STAFF RECOMMENDATION 1109 Greenwood Avenue April 20, 2016

Application: New construction—addition to outbuilding/detached accessory dwelling unit

District: Eastwood Neighborhood Conservation Zoning Overlay

GREENWOOD AVENUE
 SITE PLAN
 SCALE: 1"=10'

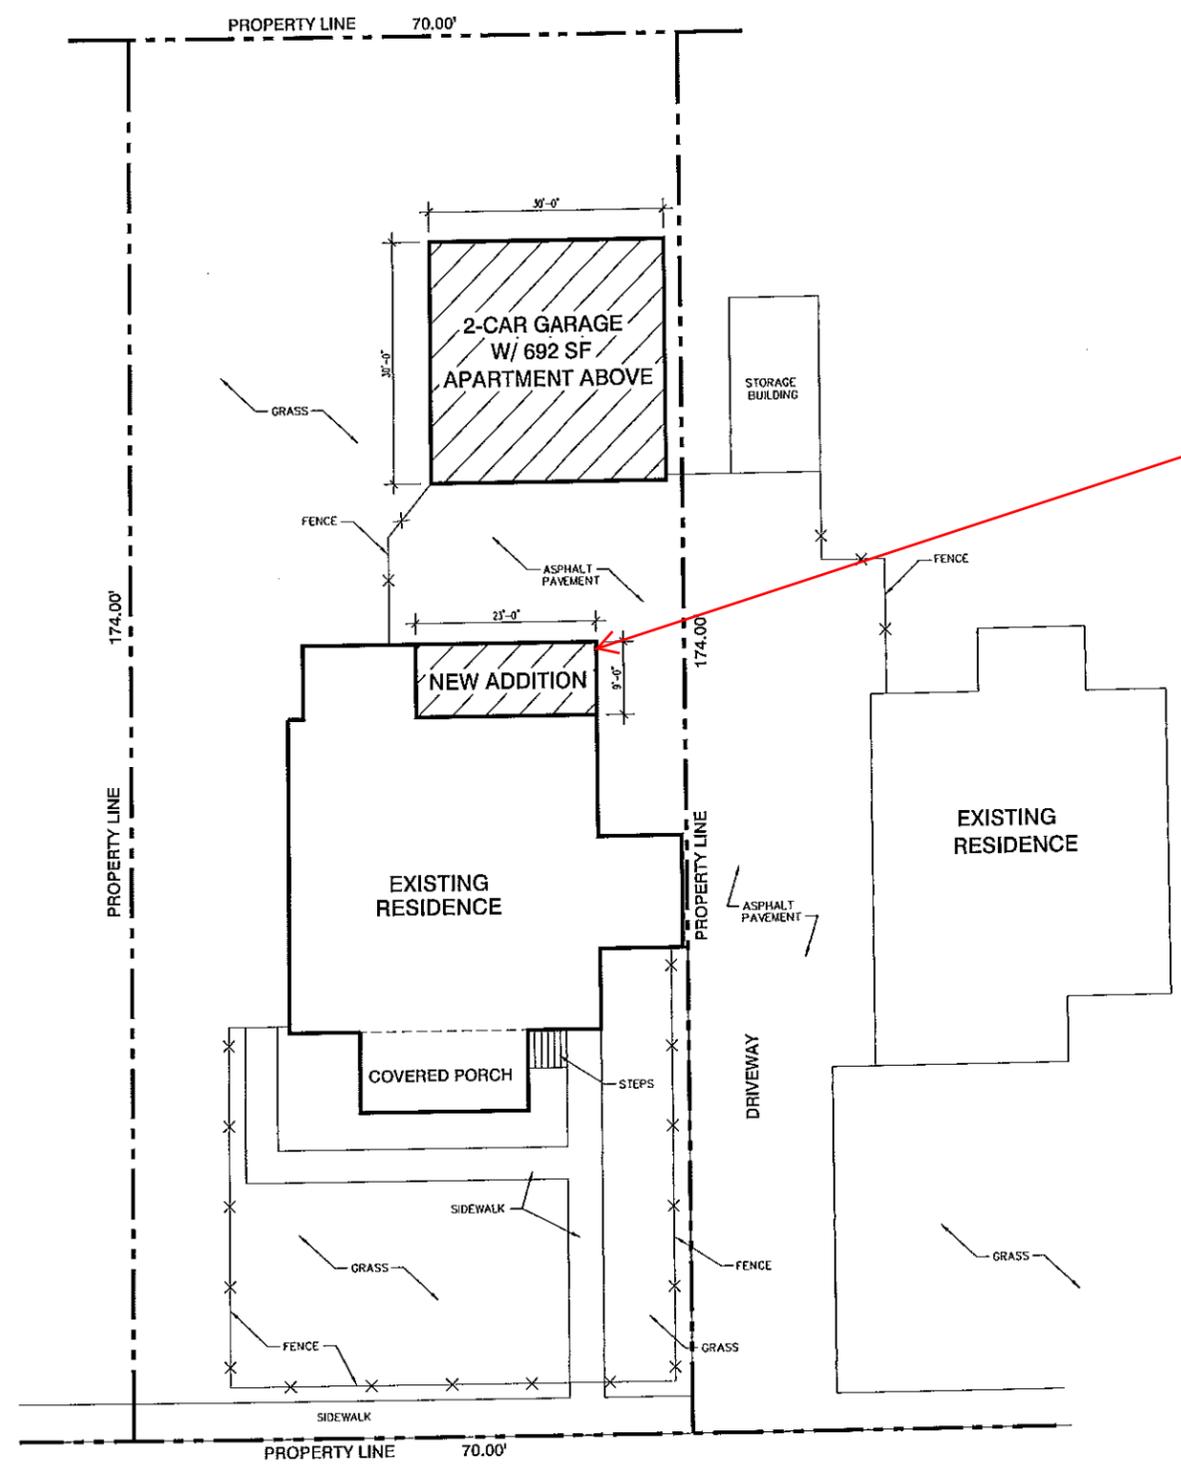
The existing outbuilding is over nine hundred square feet (900 sq.ft.), which is an appropriate footprint since the lot is over eleven thousand square feet (11,000 sq. ft.). The existing outbuilding does not meet the right side setback, as it is just two feet (2') from the rear property line. However, because the project does not involve expanding or altering the existing footprint in any way and because the structure is existing, a setback determination is not needed. (In the past, the Commission has allowed for reduced rear setbacks because outbuildings were often close to the rear lot, but not side setback reductions.)

REAR ELEVATION
SCALE: 1/4"=1'-0"

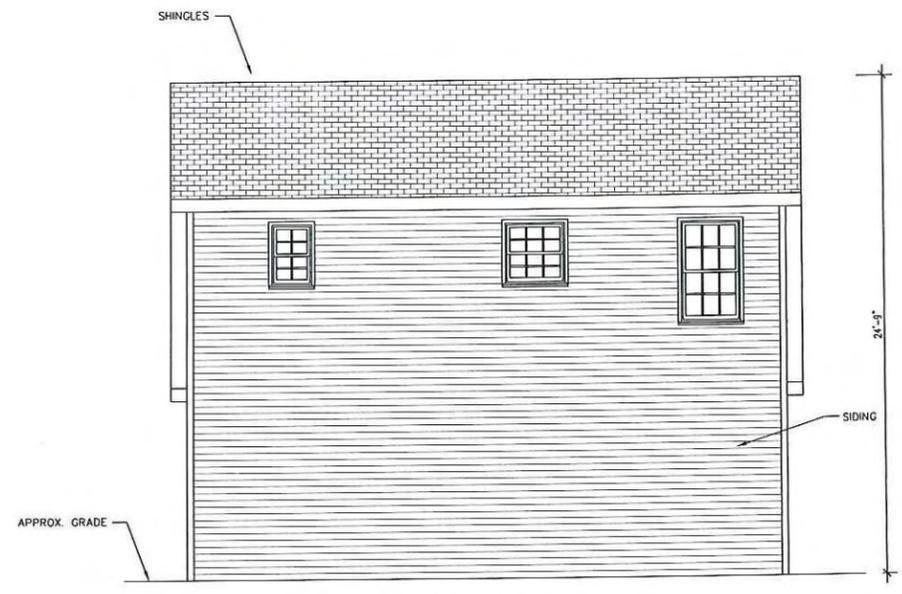
1. The eave height on the rear be reduced to ten feet (10') or less;
2. The siding be wood or smooth-face cement fiberboard with a maximum reveal of five inches (5");
3. Staff approve the final details, dimensions and materials of windows and doors prior to purchase and installation;
4. Staff approve the roof color and masonry color, dimensions and texture; and
5. Staff receive a restrictive covenant for the detached accessory dwelling unit.

The project involves removing the existing low-sloped front gabled roof and constructing a new 10/12 side-gable roof with dormers in its place. On the street-facing façade, the eave height will be approximately ten feet (10') and the ridge height will be twenty-four feet, nine inches (24'9"). There will be two gabled dormers that are set back two feet (2') from the wall below and take up less than fifty percent (50%) of the roofscape. On the rear, the eave height of the structure is approximately sixteen feet (16'), and staff recommends that the eave height be lowered to ten feet (10') in order to meet the regulations of the DADU ordinance and the design guidelines.
